# Instructions for upgrading the GROCO HC or HE toilets to an HF toilet

The evolution of GROCO's HC model toilet to HE and now HF has necessitated the addition, deletion, or modification of some parts. The changes have resulted in greatly improved toilet operation.

# PARTS & ASSEMBLY

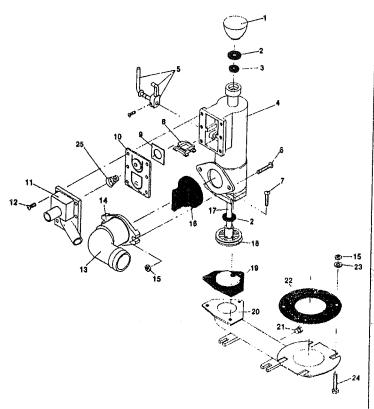
<u>Item 5</u>: <u>HF-20 Cam Assembly</u>. The HF-20 combines the cam action required to open and close the toilet inlet with a more effective vacuum breaker, resulting in easier dry-bowl pumping and a more positive shut-off of inlet water when the valve handle is placed in 'DRY BOWL'.

<u>Item 8</u>; <u>HF-28 Bridge</u>. Provides support for items 9 and 10, thus preventing loss of pump suction.

<u>Item 10</u>: <u>HF-1 Gasket</u>. This injection-molded part replaces former neoprene gaskets with bronze weights. It provides greater accuracy and more positive flushing with the valve handle in the 'FLUSH' position.

<u>Items 17, 18</u>; <u>HF-10 Piston/Ring Assembly and HF-21 Shaft.</u> This new design provides more positive flushing and a positive seal against back-flow from the toilet discharge. The HF-21 shaft is required in order to restrict the pump stroke length to 7-1/4".

<u>Item 25</u>; <u>HF-26 Spring.</u> Assures that the HF-1 gasket is properly seated in the 'FLUSH' position, allowing the pump to prime itself.

HT-49-A Joker Valve (not shown). HC and HE models used HT-49-A to break the vacuum for dry-bowl pumping, but is not used on HF. The HF Upgrade Kit includes a plug to close off the HT-49-A.

Includes items 5, 8, 10 and 25 (drawing at right), and is intended to upgrade early HF models to the current configuration. The kit will prevent unwanted bowl filling from the toilet inlet by providing a positive shut-off when the valve handle is placed in 'DRY-BOWL'. (See note below)

Includes HF Cam Kit items plus items 17 and 18, and is intended to upgrade HC and HE models to the current HF configuration. Also included is a new 'FIUSH' label and an HT-49-B plug to close off the HT-49-A vacuum breaker, which is no longer used. In addition to the improvements provided by the HF Cam Kit, the HF Upgrade Kit also prevents back-flow from the discharge side of the tollet.
